TECHNICAL SERVICE BULLETIN

Issue Date:	7-13-17
Version:	2
Bulletin No:	TSB# T-1001
Operation No:	T1001
Labor Time:	1.0 Hrs.
TSB Classification:	Mandatory TSB <input checked="" type="checkbox"/>

Subject: Engine Alternator Wire Chafing Issue	Company Segment: Power Generation
	Manufacturer: Multiquip
	Model: DCA400SSI
	Engine: Isuzu 6WG1
	Tier Rating: Tier 3

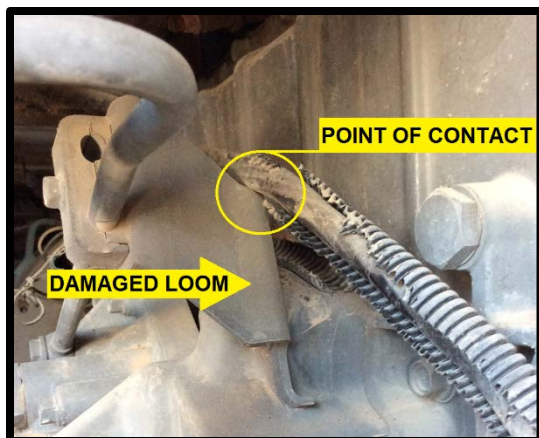
We have experienced an issue on Multiquip DCA400SSIT3 diesel generators that requires your immediate attention! We have documented an incident where the main positive and negative wiring coming off the back of the DC alternator shorted and caught fire due to wire chafing through the insulation against the fuel line bracket above the fuel filters. This potentially damaging hazardous issue is the result of inconsistent routing, dry rotted/missing loom, and improper securement of the harness and has been identified to affect all the Tier3 MQ400's in our rental fleet.

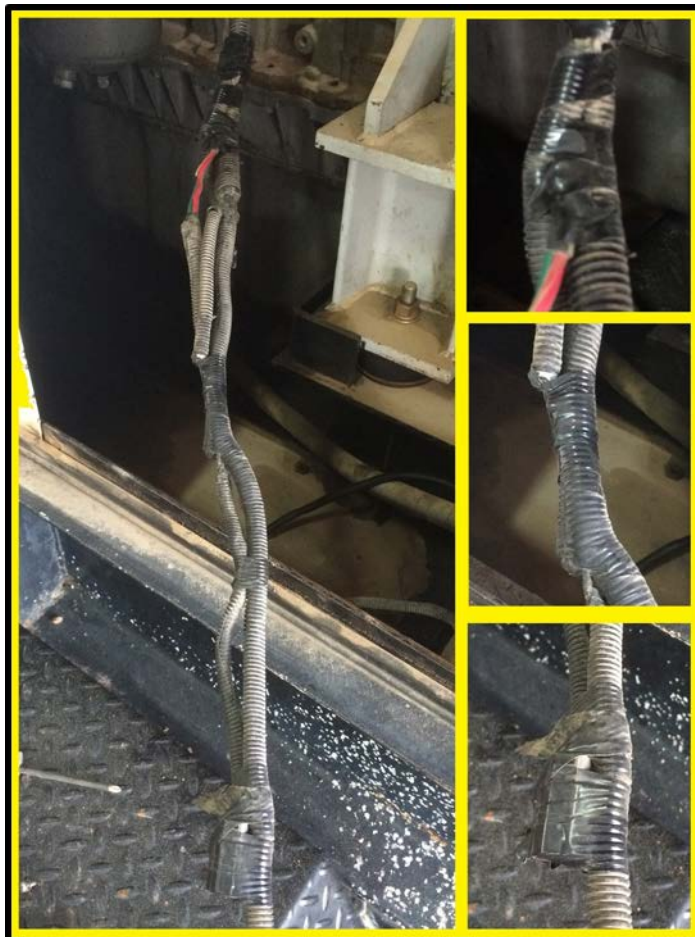
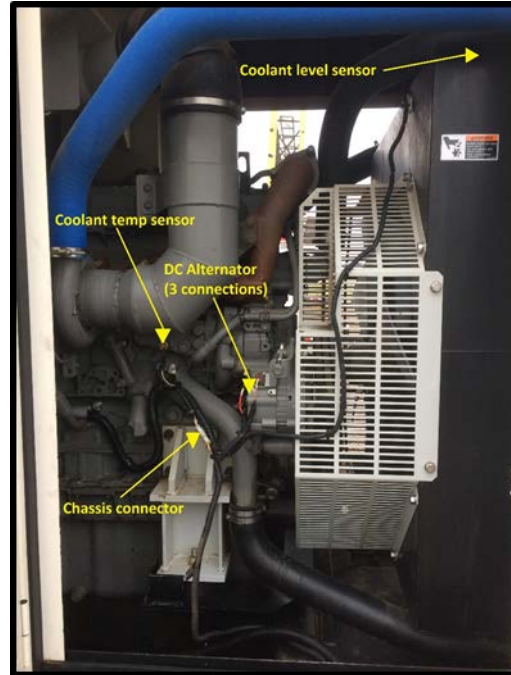
STEP 2. Do a thorough inspection of the overall condition of the wiring harness starting at the engine alternator going past the fuel filter assemblies. Inspect for damaged wire insulation, chafe points, and dry rotted/missing loom. Repair all found damage to the harness and proceed to the next step.

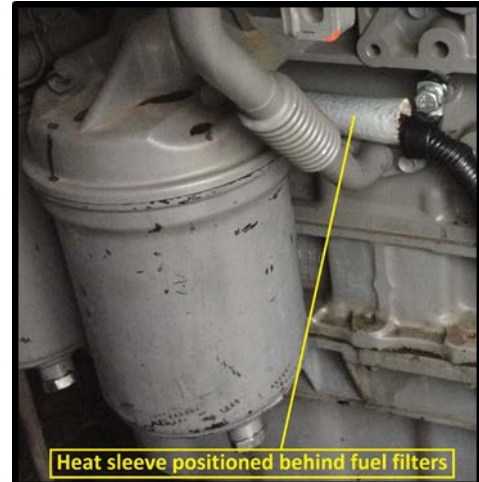
STEP 4. Replace any damaged sections of the 3/4" corrugated wire loom from the DC alternator going past the fuel filter assemblies. Wrap electrical tape around the harness and connectors temporarily in order to form a narrow profile to ease the installation of the heat sleeve material.

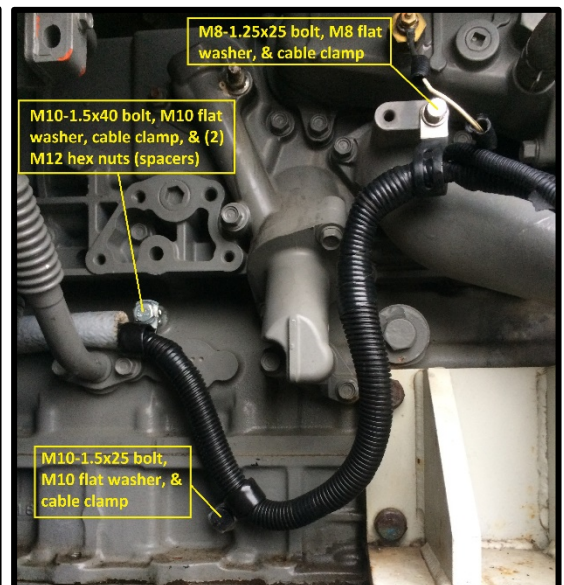
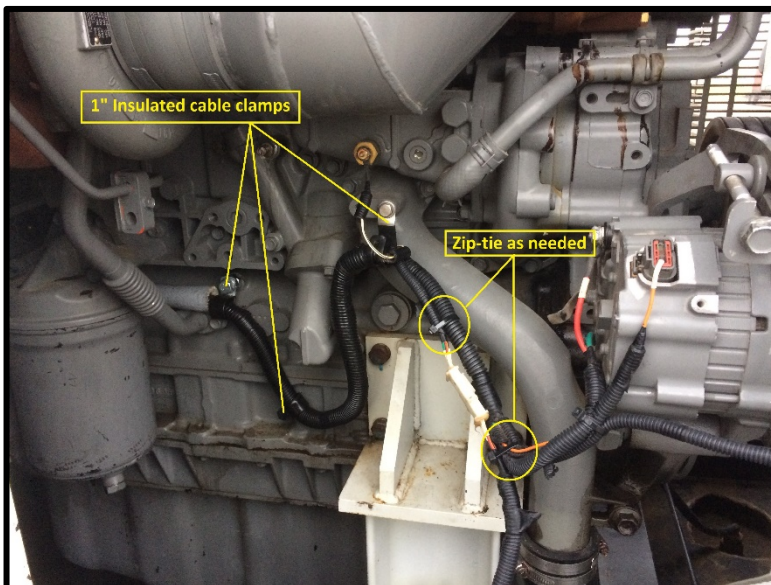
Step 6: Reroute the engine wiring harness behind the fuel filter assemblies and around engine components as shown in the below pictures. Secure the engine wiring harness using the 1" insulated cable clamps and new mounting hardware. Reconnect engine wiring harness to components and secure with zip-tie harness as needed.
